WAIMAKARIRI DISTRICT COUNCIL

Review of Vector PowerSmart Assessment of Solar Farm Glint and Glare at 87 Upper Sefton Road Ashley

Date: 3 April 2024

Velden Aviation Consulting Ltd

Figure 4.3 Predicted glare occurrence for Rail for FT PV array 1

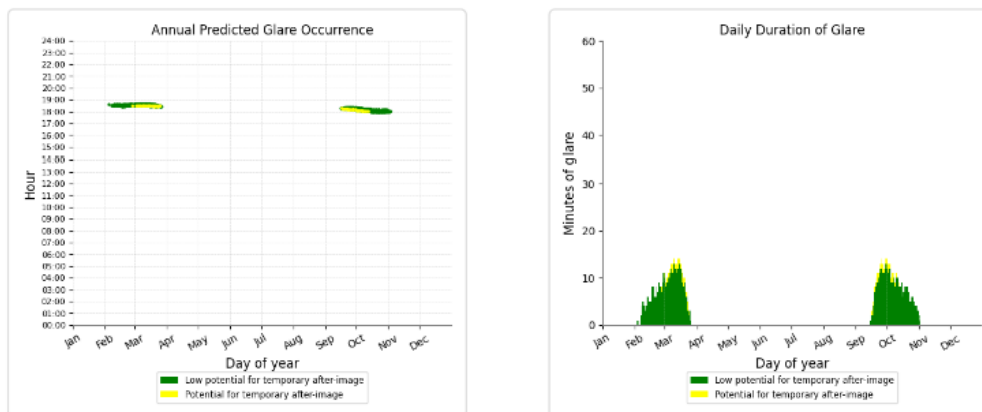
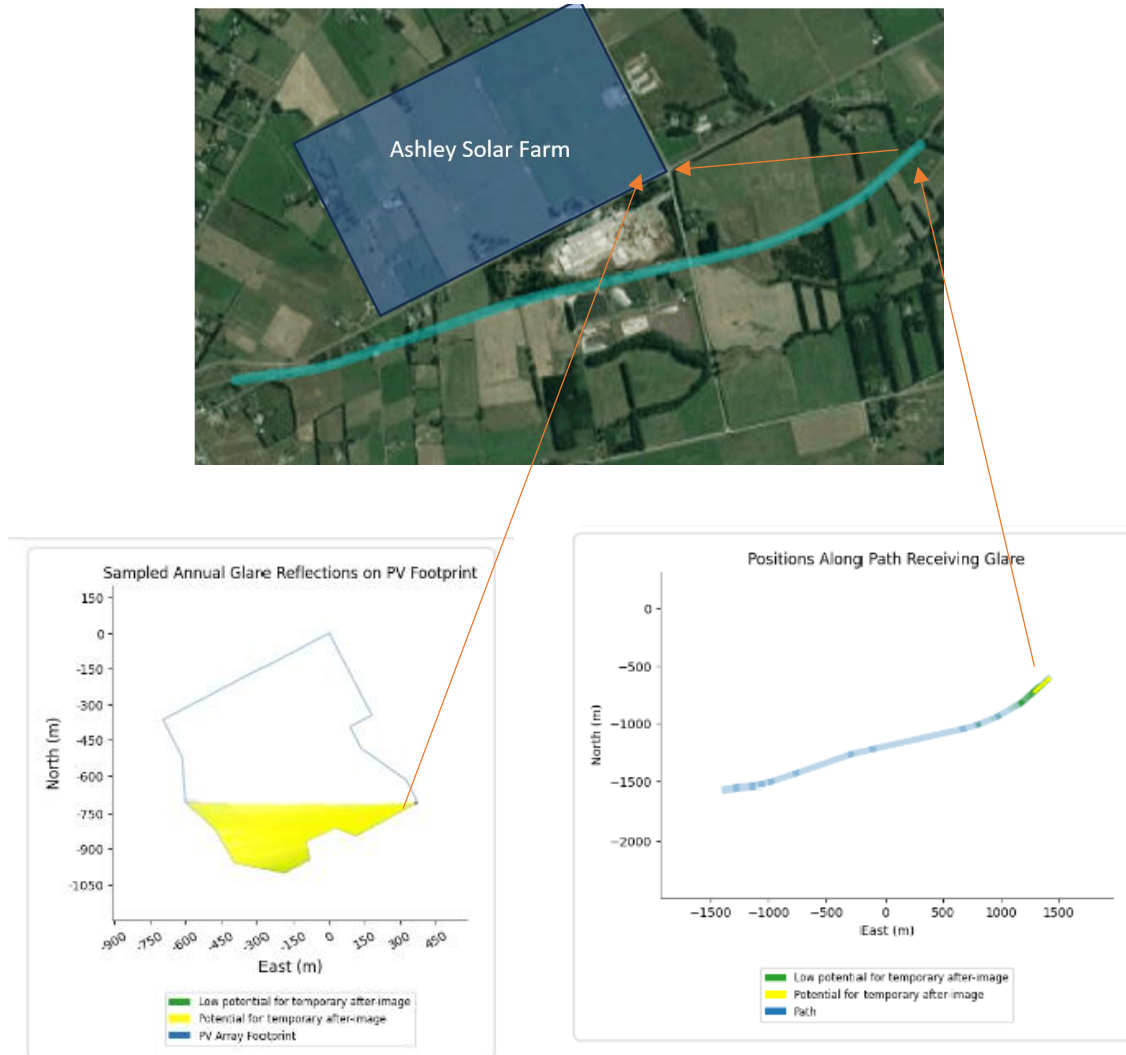
This is also mostly green level glare which is not significant for dynamically moving vehicles due to its low level impact. The yellow level glare is also of short duration as indicated in the plots below which show it is less than 5 minutes duration between 6pm and 7pm and during months of early Feb to late April and from mid-September to end of October. (See Figure 4.3 below)

The footprint below and location on the railway path indicates where this is happening.

Although a 4m shelterbelt is expected to obscure any view for the train driver at this point the mechanism by which the simulation may be showing yellow glare or in fact any glare from this point is if either the height of the terrain at the driver location and the solar farm location is significantly different.
